SUBJECT: SUSQUEHANNA STEAM ELECTRIC STATION, UNIT 2, CYCLE 5 RELOAD
(TAC NO. 79140)

AMENDMENT TO FACILITY OPERATING LICENSE

Amendment No. 76
License No. NPF-22

SAFETY EVALUATION BY THE OFFICE OF NUCLEAR REACTOR REGULATION
RELATED TO AMENDMENT NO.76 TO FACILITY OPERATING LICENSE NO. NPF-22

TOTAL CORE FLOW (% OF RATED)
FLOW DEPENDENT MCPR OPERATING LIMIT
FIGURE 3.2.3-1

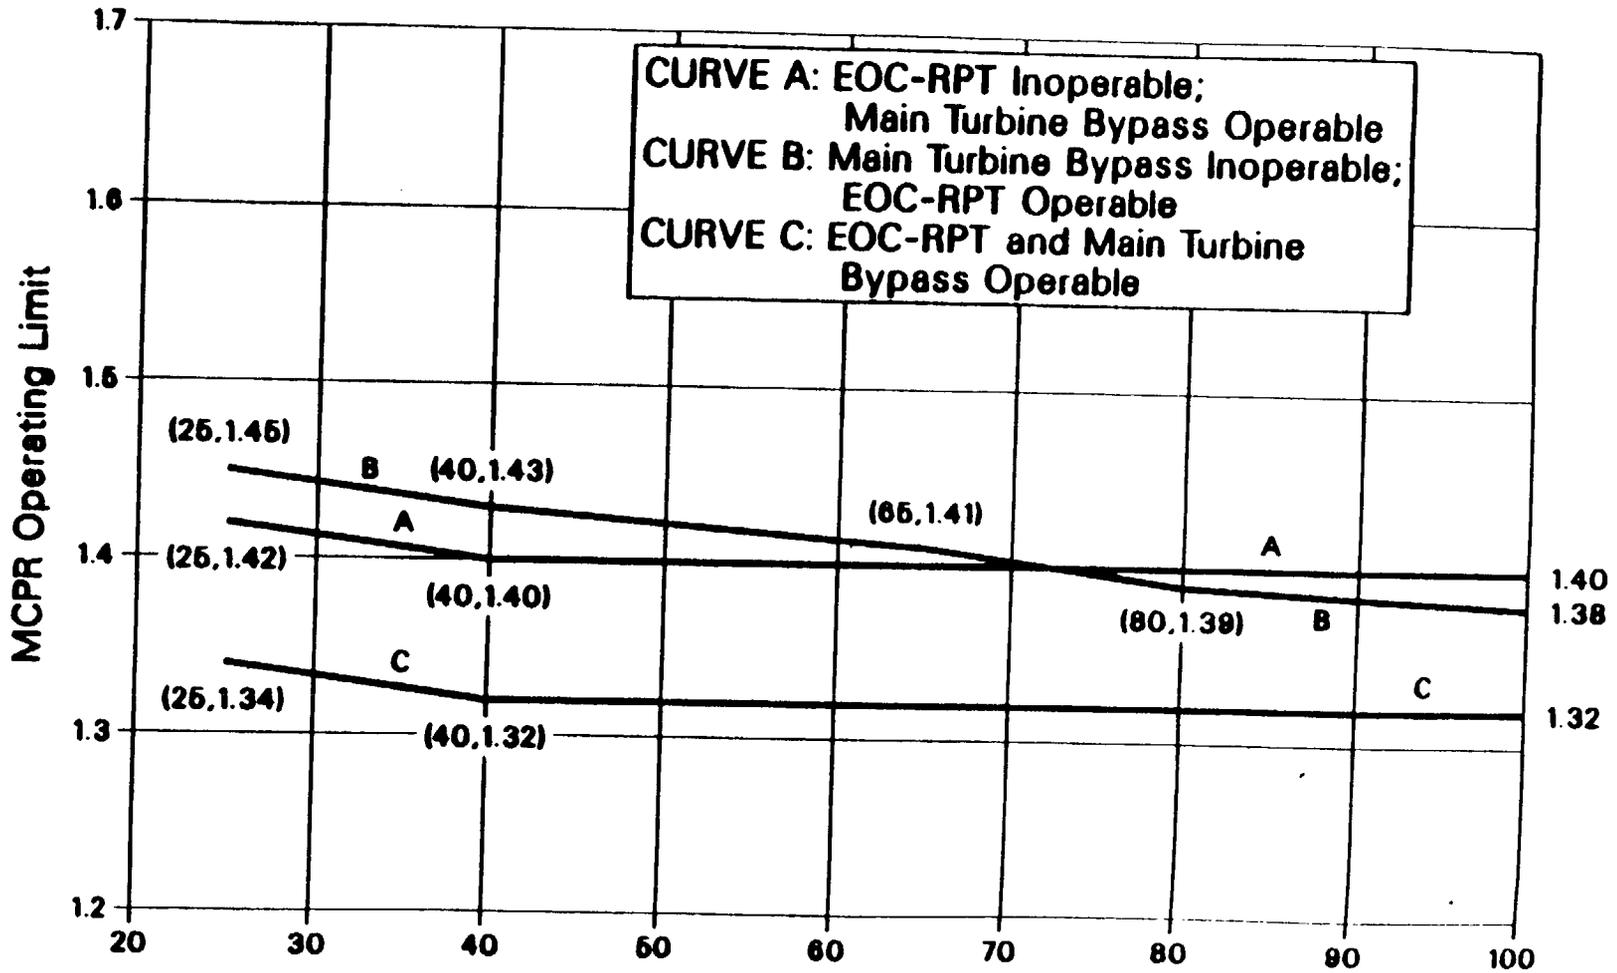
condition is the generator load rejection without bypass event (LRWOB). The delta CPR for this event is 0.26. When combined with a safety limit MCPR of 1.06 this results in a MCPR operating limit of 1.32 for S2C5. The most limiting local transient, the control rod withdrawal error (CRWE), was analyzed to support a rod block monitor (RBM) setpoint of 108 percent and resulted in a delta CPR of 0.23. The LRWOB and the CRWE events were the most limiting events for S2C5 at rated power and flow conditions. At less than rated power, the feedwater controller failure (FWCF) event is limiting and a curve of MCPR versus power, which is based on the FWCF results, is included in the Technical Specifications as a power dependent MCPR operating limit.

At reduced flow conditions, the recirculation flow controller failure transient (RFIT) is limiting and MCPR operating limits for manual flow control reduced flow operation for S2C5 based on the analysis of this event are provided as a Technical Specification Figure of MCPR versus core flow. The calculations of the thermal margin were performed with approved methodology (Ref. 17) and the resulting Technical Specification limiting curves are acceptable.

4. Specification 3.2.3: The MINIMUM CRITICAL POWER RATIO (MCPR) shall be greater than or equal to the largest of the following values:

- a. the MCPR determined from Figure 3.2.3-1 plus 0.01, and
- b. the MCPR determined from Figure 3.2.3-2 plus 0.01.

Figure 3.4.1.1.1-1
THERMAL POWER RESTRICTIONS

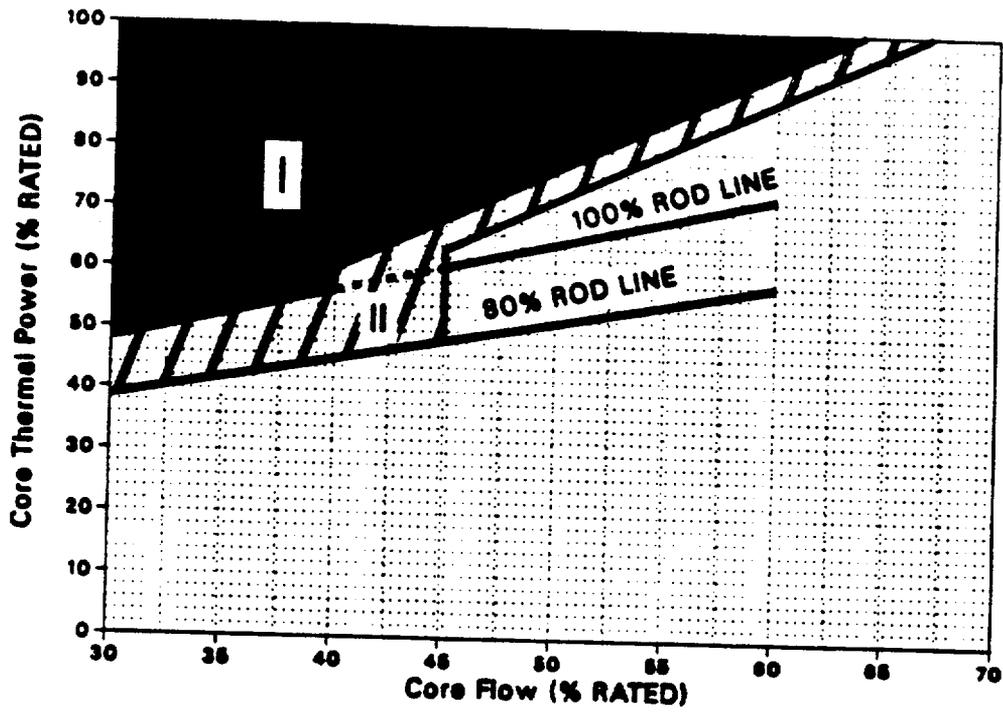
- (2) TS 3/4.4.1 -- Figure 3.4.1.1.1-1 is changed to reflect the calculated changes in the regional stability boundaries, as was previously discussed. The change is acceptable.

3.4.1.1.2 One reactor coolant recirculation loop shall be in operation with the pump speed < 80% of the rated pump speed and the reactor at a THERMAL POWER/core flow condition outside of Regions I and II of Figure 3.4.1.1.1-1, and

- a. In OPERATIONAL CONDITION 1:
 1. With
 - a) no reactor coolant system recirculation loops in operation, or
 - b) Region I of Figure 3.4.1.1.1-1 entered, or
 - c) Region II of Figure 3.4.1.1.1-1 entered and core thermal hydraulic instability occurring as evidenced by:

2. If Region II of Figure 3.4.1.1.1-1 is entered and greater than or equal to 50% of the required LPRM upscale alarms are OPERABLE, immediately exit the region by:
